WHITE PAPER NO. 5B – EVALUATION OF API CAPPING COSTS REPORT

Response to a Document by The Johnson Company

**ECOSYSTEM-BASED REHABILITATION PLAN –
AN INTEGRATED PLAN FOR HABITAT ENHANCEMENT AND
EXPEDITED EXPOSURE REDUCTION IN THE
LOWER FOX RIVER AND GREEN BAY**

This Document has been Prepared by
Wisconsin Department of Natural Resources

Figure 1 Increase in Costs with Incremental Increase in Cap Thickness

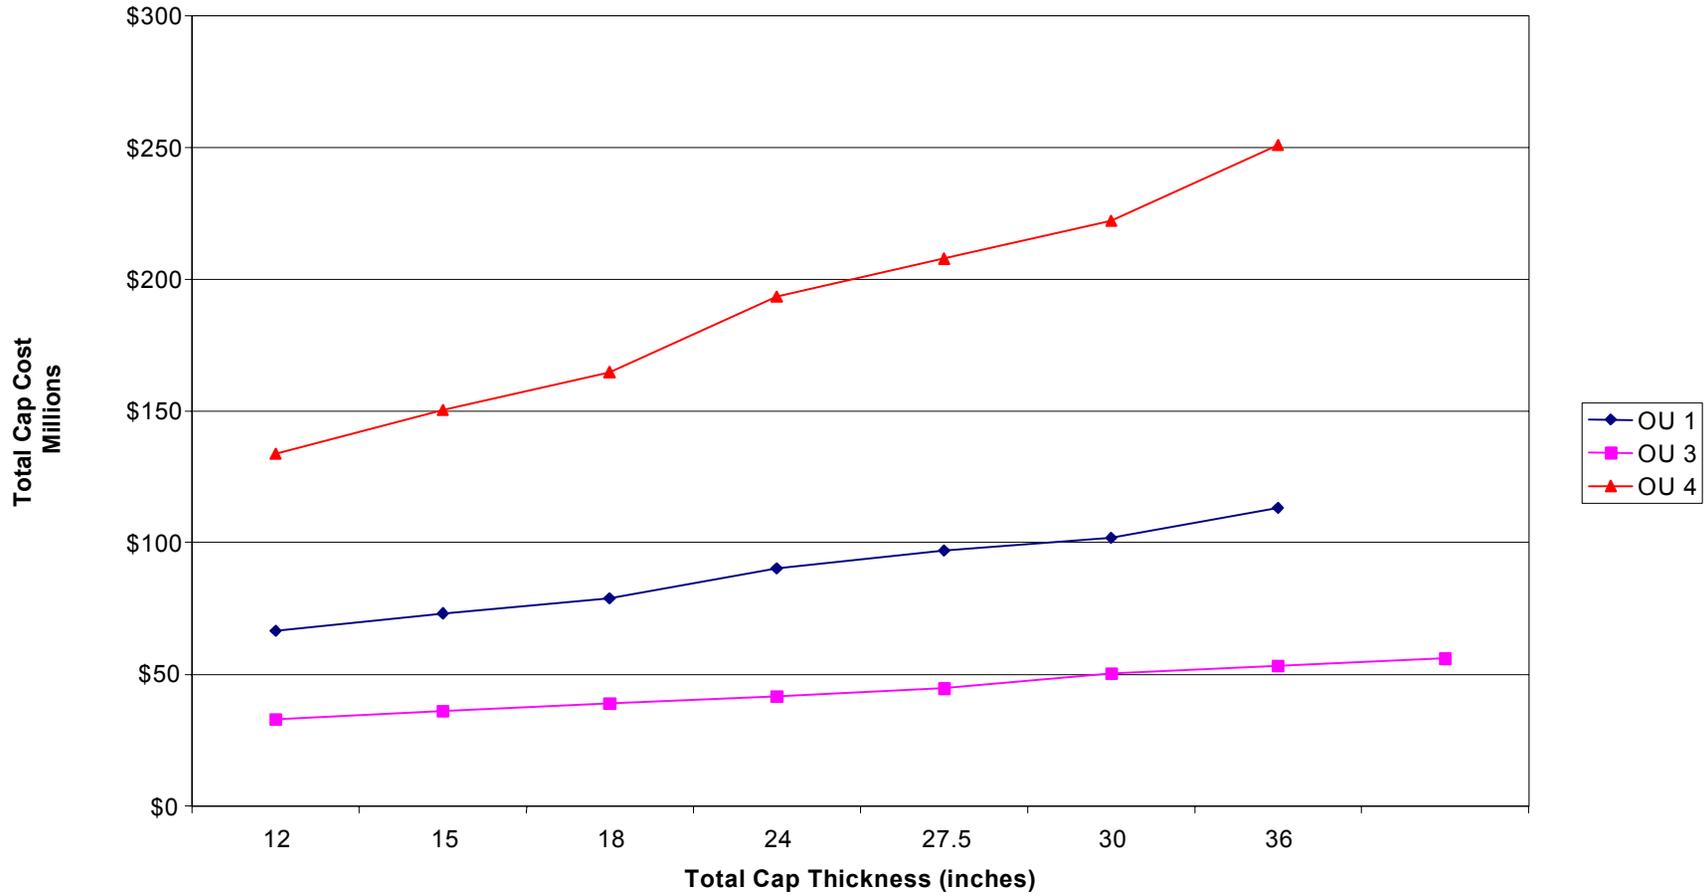
Table 5 presents the incremental increase in cost for adding additional layers of sand to the cap for chemical isolation. These costs were determined using the same assumptions and numbers that are listed in the Panel Report's Cost Analysis, and are only for the 5 ppm RAL footprint. As can be seen on Figure 1, the costs are relatively linear and add 3 to 4 percent per inch of additional isolation layer. The required effective cap thickness for each of the OUs is highlighted in Table 5 and increase the Panel Report costs by 27 to 45 percent. When compared then to the cost at the 1 ppm RAL (Table 3), the removal alternatives in the WDNR and EPA's Proposed Plan are still favorable to capping in OUs 1 and 3, and comparable to capping in OU 4. If these costs are then adjusted by a factor of 2 to account for the larger area within the 1 ppm RAL (see Table 2), the removal alternatives in all OUs are more cost effective than those proposed in the Panel Report.

- The capping design offered by the Panel Report did not consider addition of a foundation layer, nor incorporate any safety factors. Based on engineering judgment and experience at other sites, the API Panel cap thickness requires an additional 8 to 12 inches.

- When the technical adjustments to the cap design are applied, along with an accounting for the larger remedial footprint, the cost of the API Panel cap is either greater than, or equivalent to the cost of removal in all OUs.
